Remarks/Arguments:

Applic.. No. 10/642,544
Amdt. dated October 17, 2005
Reply to Office action of May 17, 2005

Drawing Amendments

Fig. 2

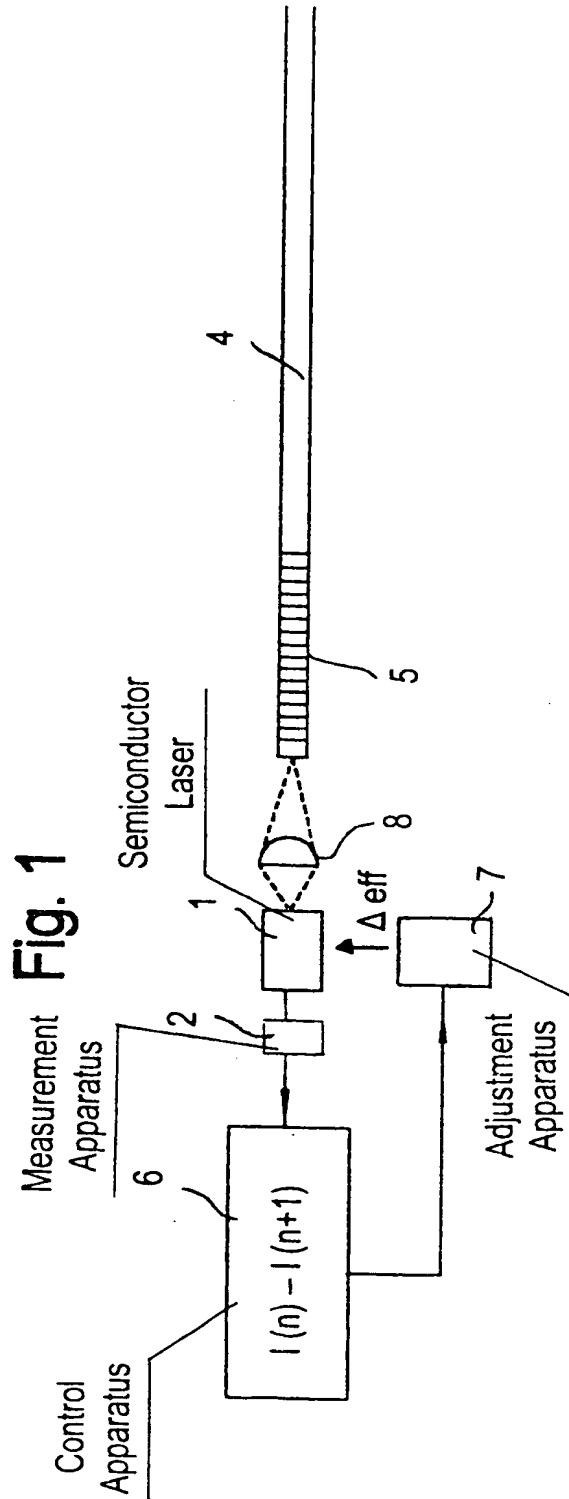
In the second paragraph on page 2 of the above-identified Office action, the drawings have been objected to because it is believed that the caption of reference numeral "21" should be "highly reflective layer" and not "highly reflective laser". As noted above in the Drawing Amendments section, Fig. 2 has been changed to read "highly reflective layer". Therefore, the objection to the drawings by the Examiner is believed to have been overcome.

The attached sheet of drawings includes changes to Fig. 2. This sheet which includes Figs. 1 and 2, replaces the original sheet including Figs. 1 and 2. In Fig. 2, the descriptor for reference symbol "21" was changed to "highly reflective layer".

Please approve the drawing changes that are marked in red on the accompanying "Annotated Sheet Showing Changes" of Figs. 1 and 2. A formal "Replacement Sheet" of amended Fig. 2 is also enclosed.
